**Federal Highway
Administration**

Refer to: HNG-14

This is in response to your July 13 letter to Mr. Artimovich requesting acceptance by the Federal Highway Administration (FHWA) of Pole Lite Model F-1300 and F-1302 cast aluminum transformer bases for use on Federal-aid highway projects. Tests were conducted to assess compliance of the bases with FHWA breakaway requirements, which cite Section 7 of the 1985 American Association of State Highway and Transportation Officials' (AASHTO) Standard Specifications for Structural Supports for Highway Signs, Luminaires and Traffic Signals. The Southwest Research Institute forwarded copies of the five crash test reports (Project No. 06-3116-516), dated June 1990, containing results of the pendulum tests on various aluminum and steel poles with these bases. Fully dimensioned drawings and material test reports on the aluminum castings had been received from you on May 31.

Figure 3. Assembly Drawing, Akron Foundry Test 14

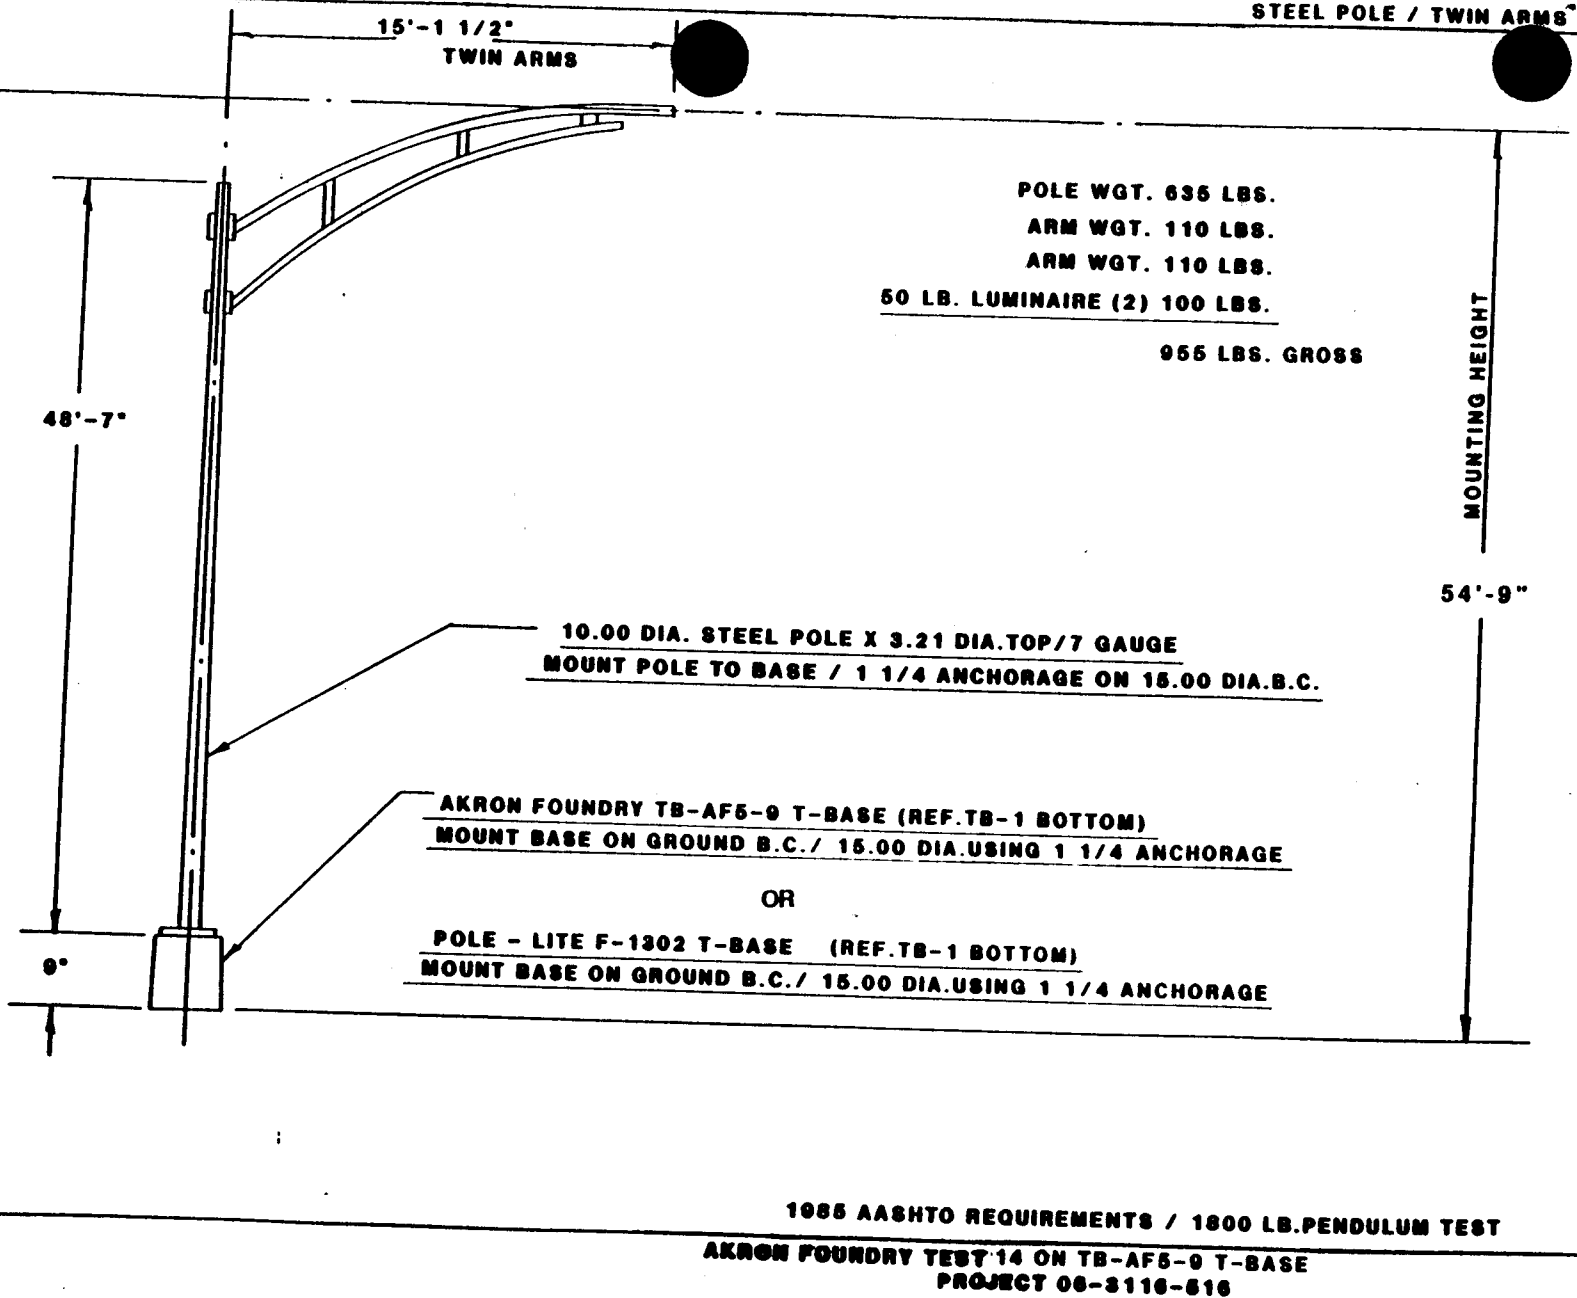
The 16.8 fps calculated change in velocity of Test 14 exceeds FHWA requirements. However, as the calculated changes in velocities nearly always over estimate the 60-mph results, we will consider the results of Test 14 as meeting the new FHWA requirements.
